# Wisconsin Department of Transportation

**Proposal #08: 4986-00-22, WISC 2017 007**  
**C Fond du Lac, CTH VV**  
**Hickory Street to Rogersville Road**  
**CTH VV**  
**Fond du Lac County**

This is Addendum No. 01, which provides for the following:

**ADDENDUM NO. 01**

Addendum No. 01  
 ID 4986-00-22  
 Revised Sheet 414  
 January 3, 2017

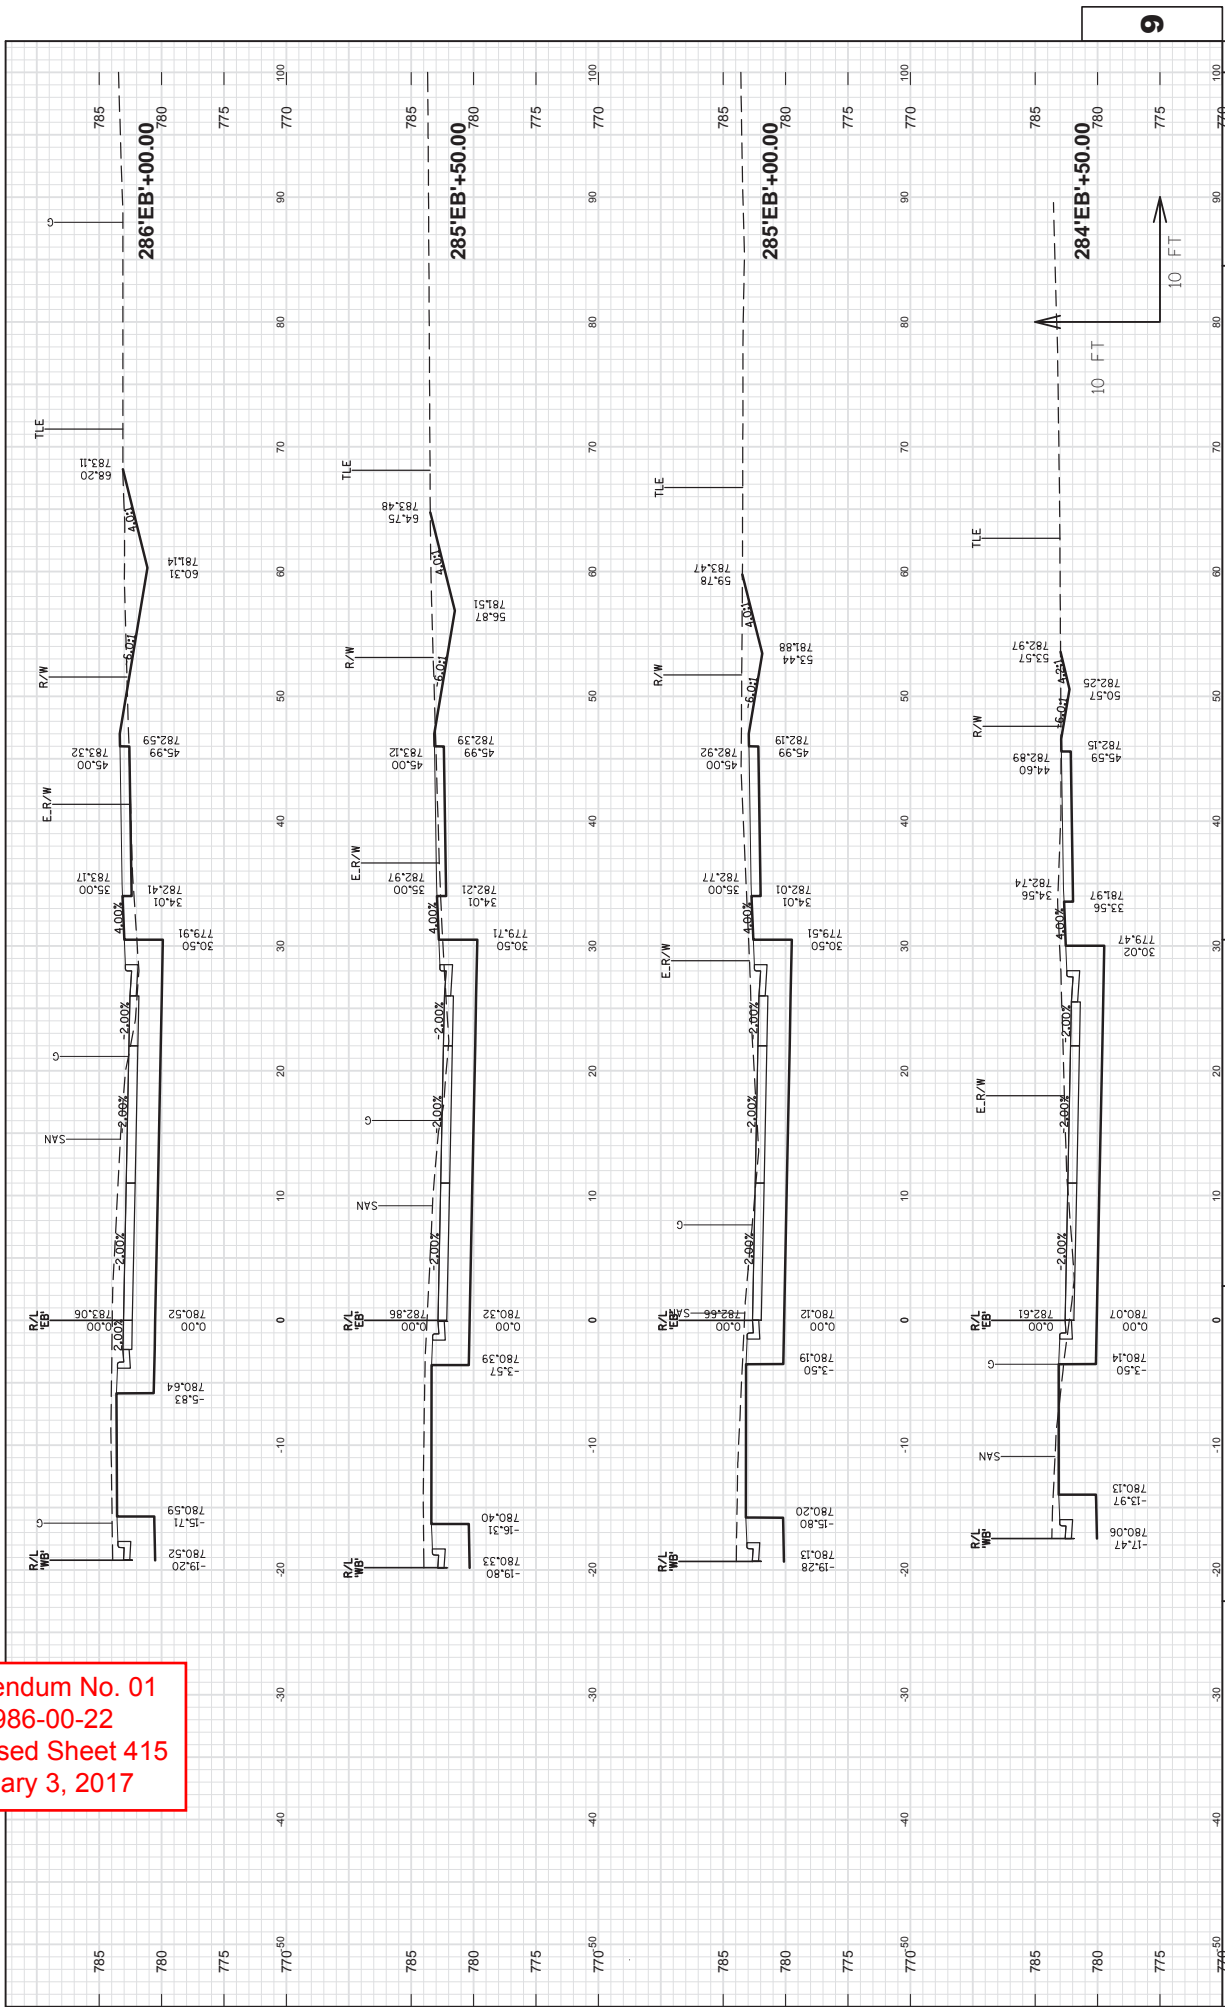
Revised Plan Sheets	
Plan Sheet	Plan Sheet Title (brief description of changes to sheet)
414-428, 430-434, 451-453	Updated the asphaltic path pavement structure depth to match the typical sections
